ADDENDUM NUMBER 5  
Building 470 Renovations  
Clarifications  
Bid #02112015-007

JOB # / PROJECT TITLE  
14-06  
BROOKS CITY BASE  
BUILDING 470 RENOVATION

ADDENDA #5

SHEET TITLE / #  
PICTURE RAIL  
A3.01-R

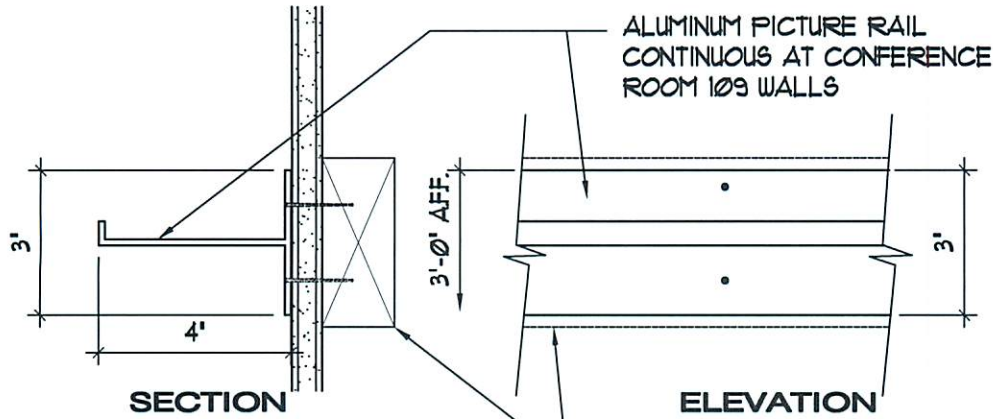
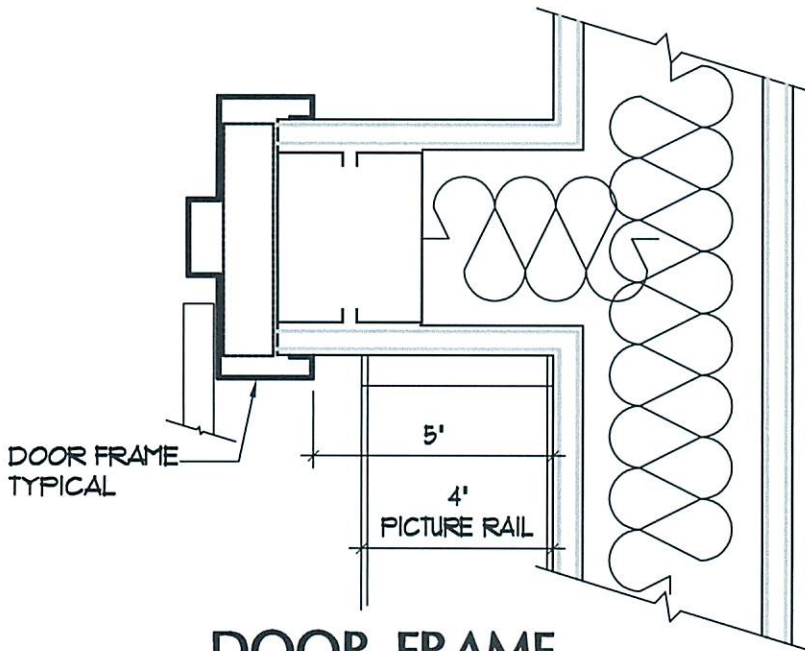
- 1) Sheet A3.01      Detail 07/A3.01, Revision: In lieu of fabricated wood chair rail shown on detail 07/A3.01 and revised in Addendum #2, provide and install extruded aluminum picture rail manufactured by Gus Design Group Inc. 223 Evans Avenue, Toronto, Ontario, M8Z1J5, or approved equivalent. Picture rail shall be continuous at all walls of Conference Room 109. Install doors and frames to allow for continuous picture rail installation. See attached Addendum 5 Revised Drawing 07/A3.01R.

NOTE: INSTALL DOORS AND  
FRAMES IN CONFERENCE  
ROOM 109 TO ALLOW FOR  
CONTINUOUS PICTURE RAIL  
ALL WALLS

ALUMINUM PICTURE RAIL  
CONTINUOUS AT CONFERENCE  
ROOM 109 WALLS

PROVIDE 2x4 WOOD  
BLOCKING CONTINUOUS IN  
WALLS FOR PICTURE RAIL IN  
CONFERENCE ROOM 109
